# Meridian Firs Apartments

## Deck Repair

Meridian Firs Apartments - Deck Repair  
Puyallup, Washington  
**PRDK20241965**

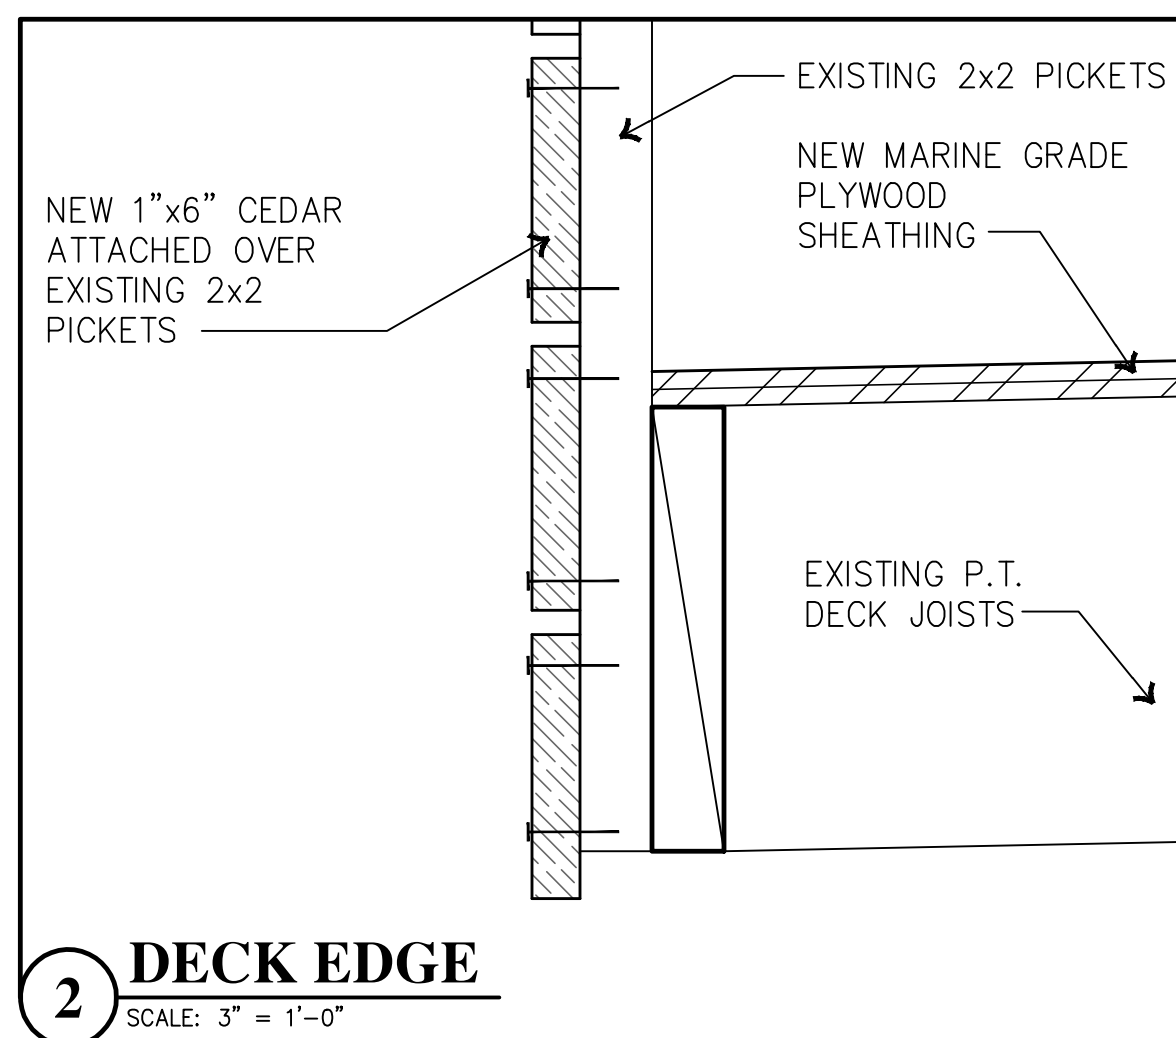
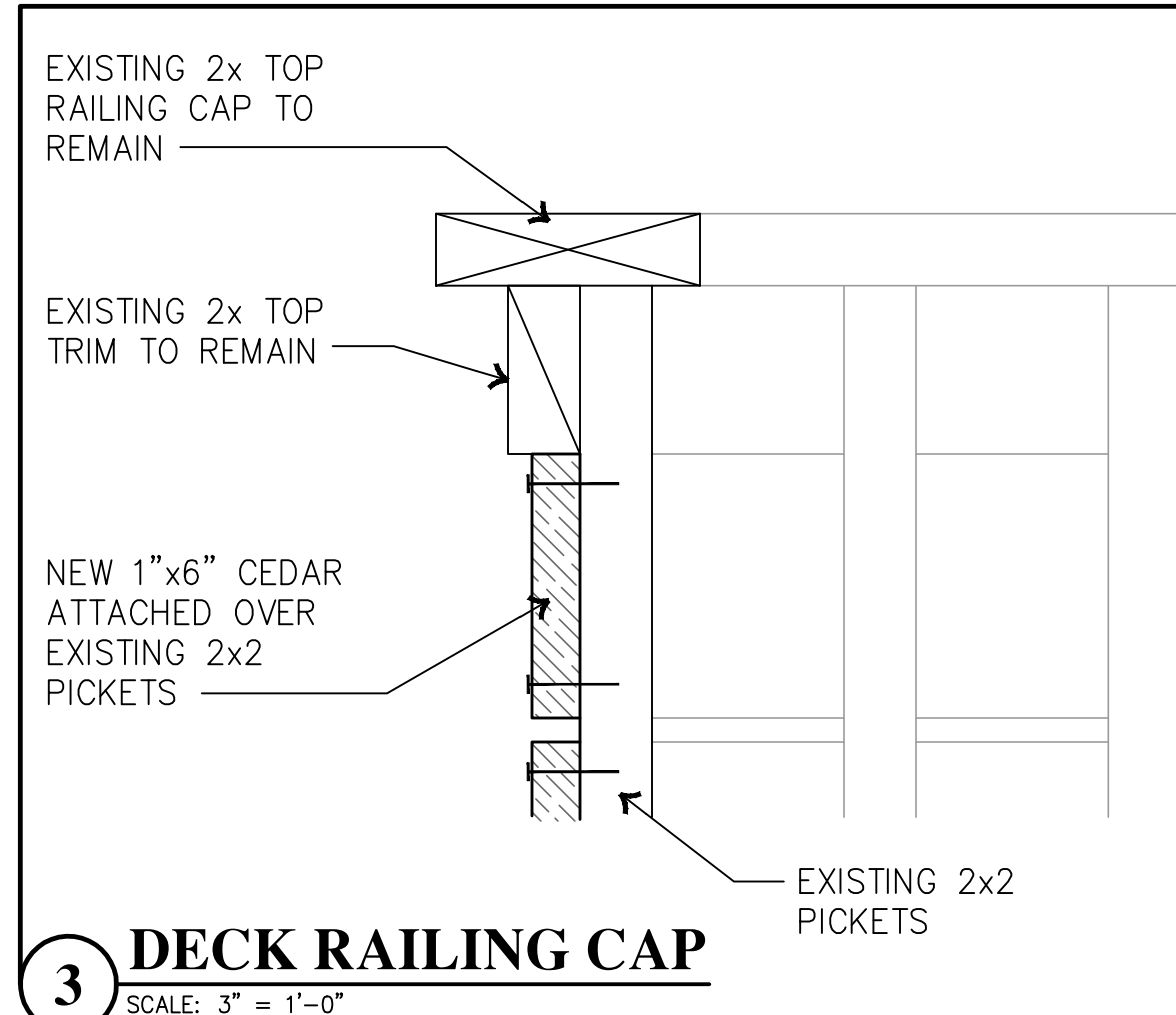
Detail the connection between the existing and proposed slab.  
(Construction Plans, Sheet A1.1, Detail 1a)

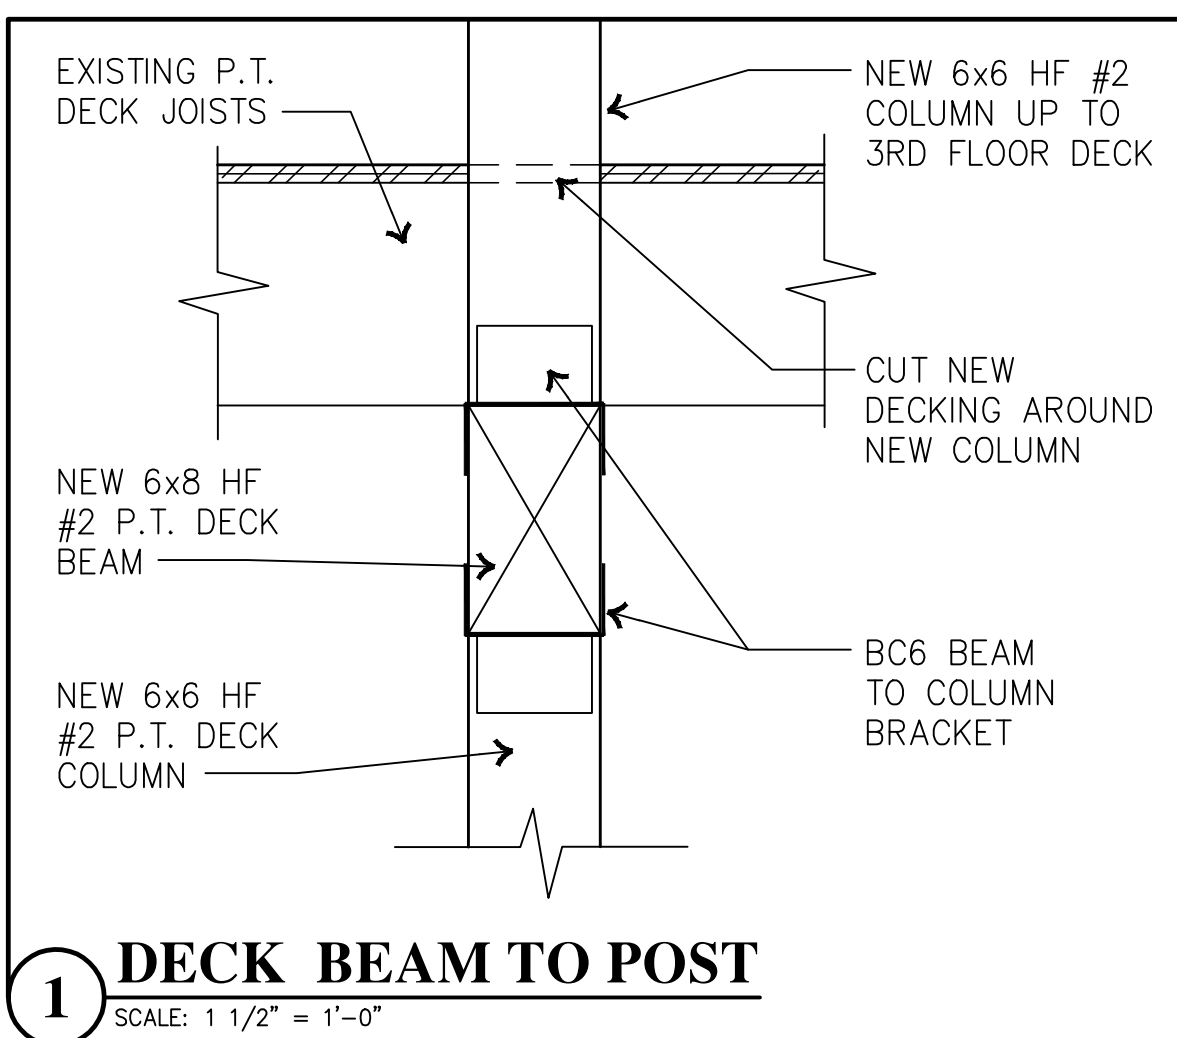
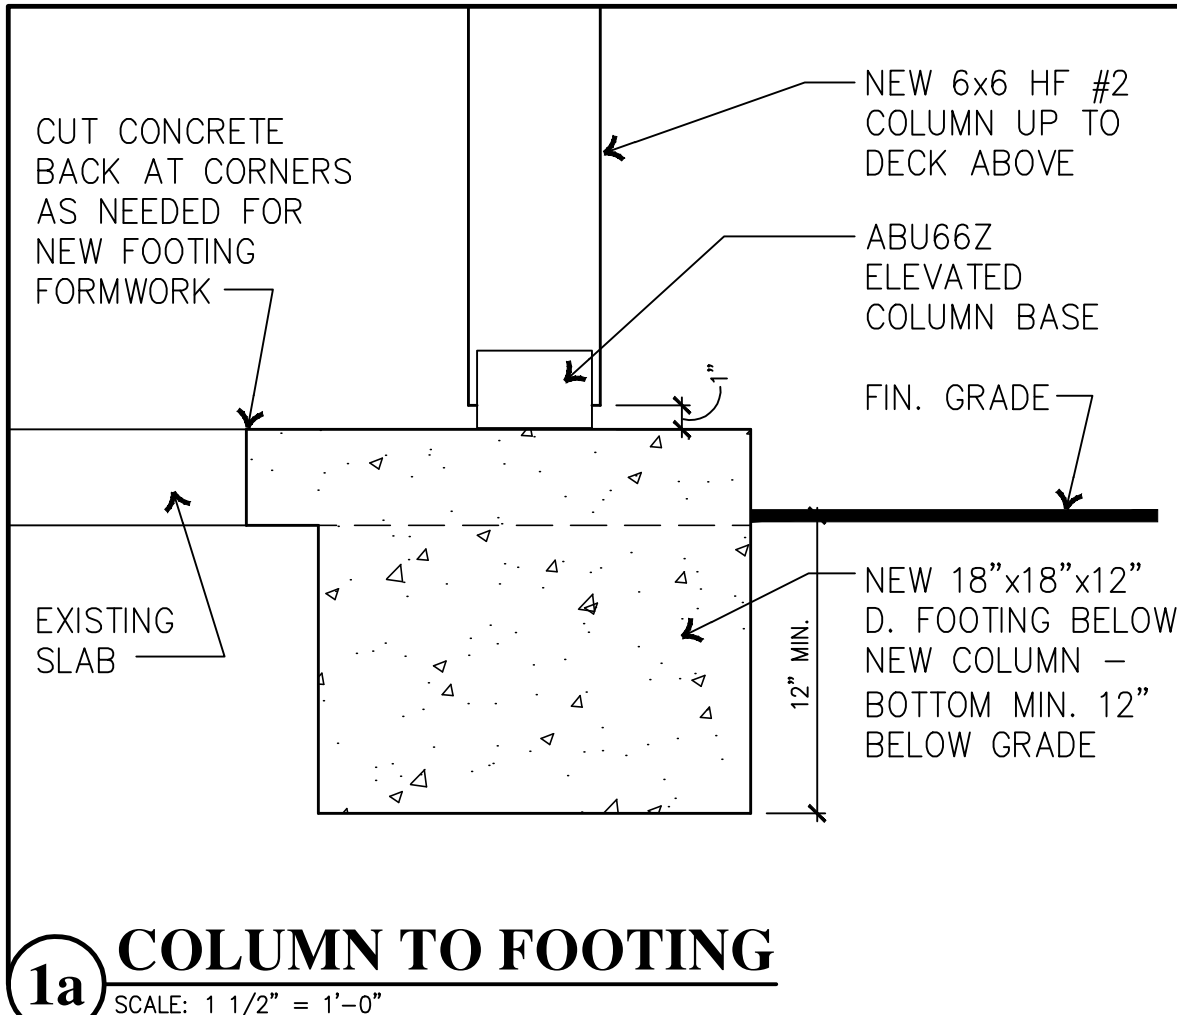
Add a notation on either Sheet A1.0 or A1.1 that contractor shall verify the integrity of balusters prior to the installation of the 1x6 cedar. Establish the parameters of the balusters replacement to include type, grade and nailing pattern.  
(Construction Plans, Sheet A1.1)

Deck joists appear to be sloped to drain off of the cantilevered side of each deck based upon details 1 and 2. Detail 2 shows the installation of the 1x6 cedar board over the existing 2x2 balusters. detail or notate how the 1x6 cedar will be installed to prevent drainage and water accumulation on the deck surface.  
(Construction Plans, Sheet A1.1)

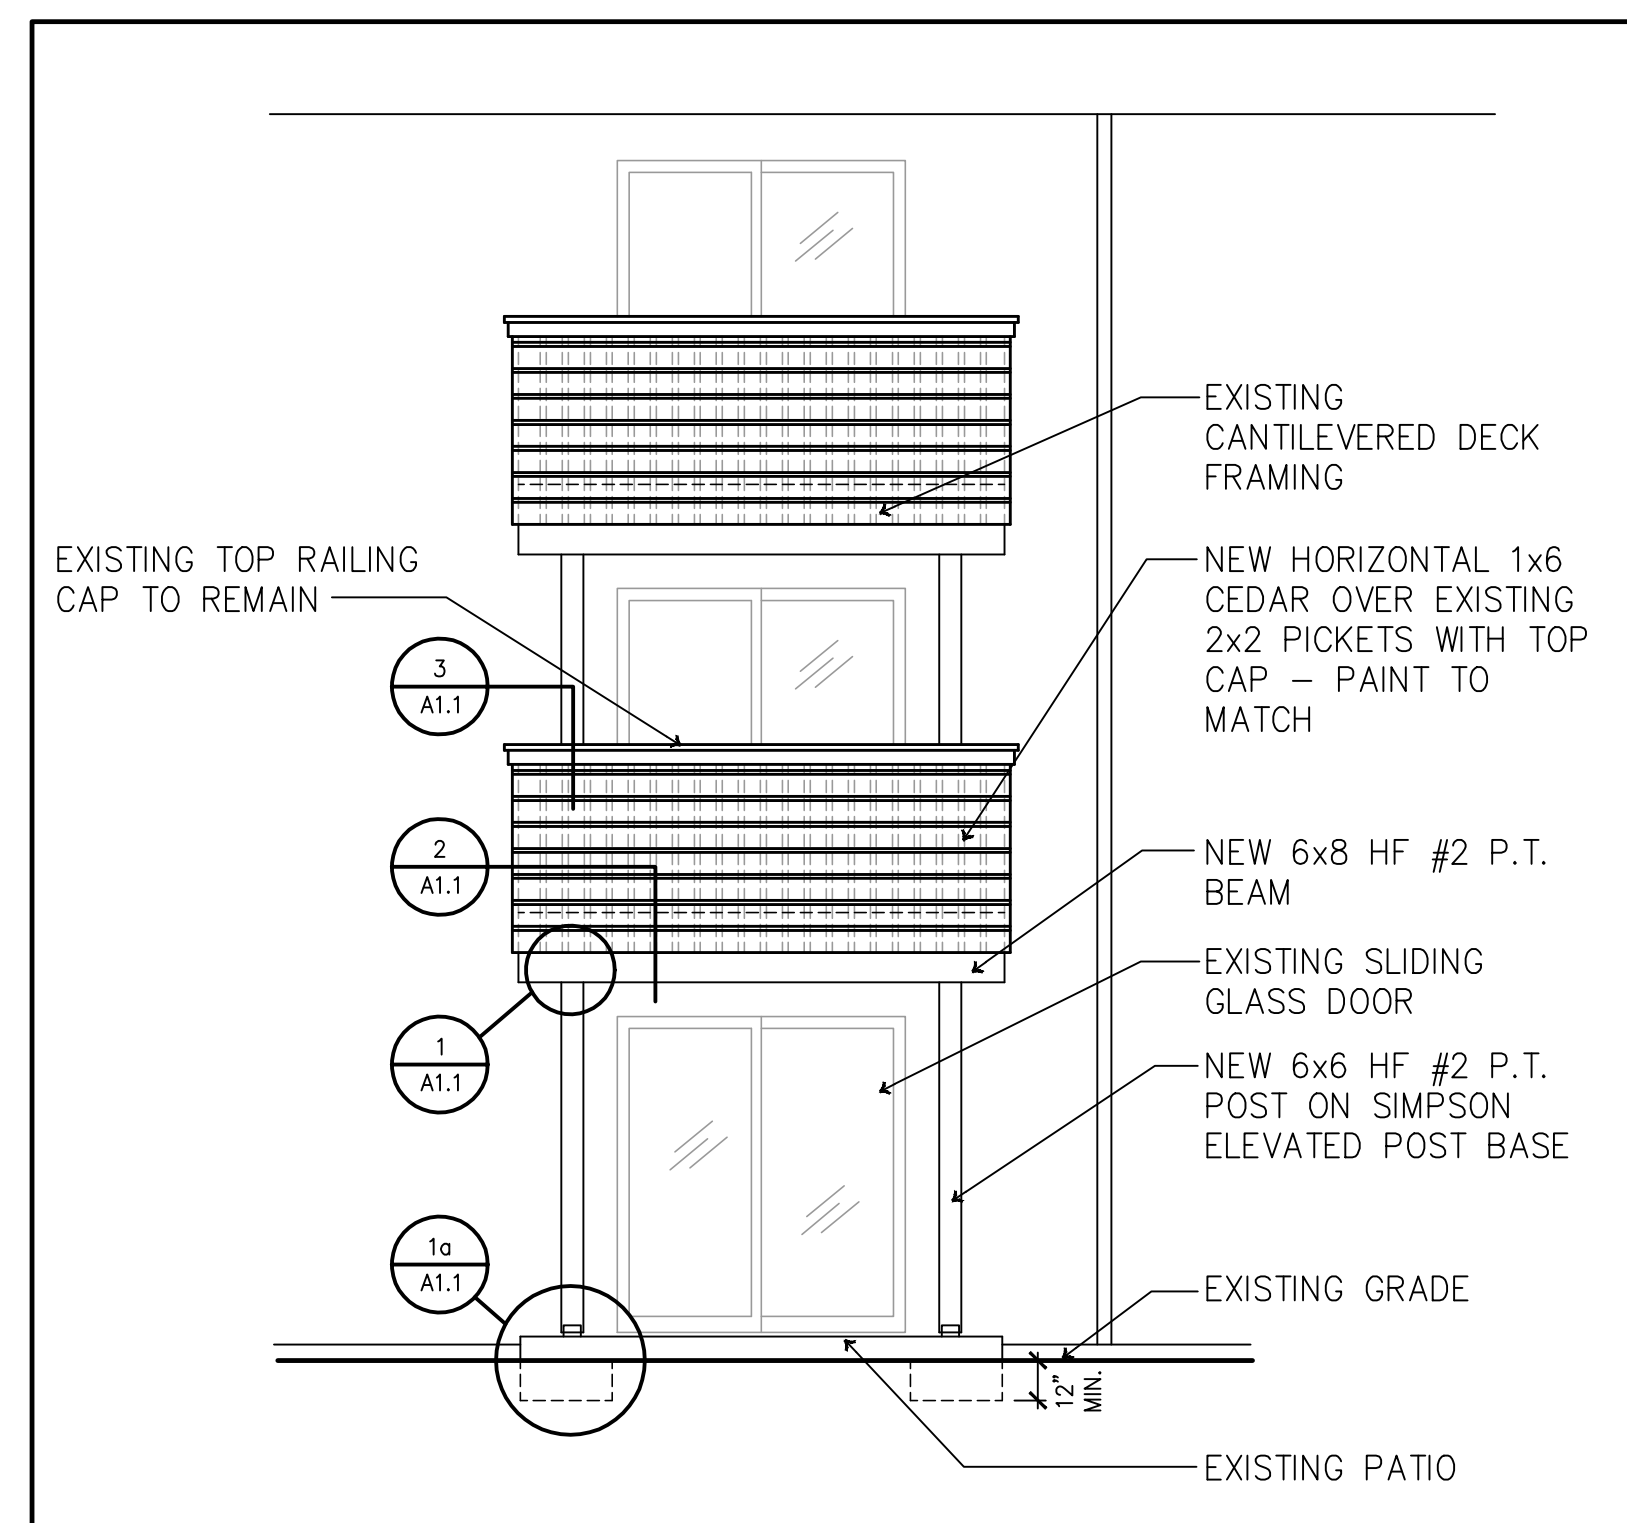
Provide specifics of the plywood that will be installed which should include plywood thickness, grade and any other specifics that will reflect that the plywood will withstand the dead and live loads of the deck. Identify the non-slip surface that will either be provided on the plywood or will be added to the plywood as part of construction, as notated on sheet A1.0, Owner/Contractor Coordination Notes.  
The existing joist spacing should also be considered when selecting the plywood material that will be used. Please provide the existing joist spacing.  
Updated all details and notes as needed to reflect the requested information.  
(Construction Plans, Sheet A1.1)
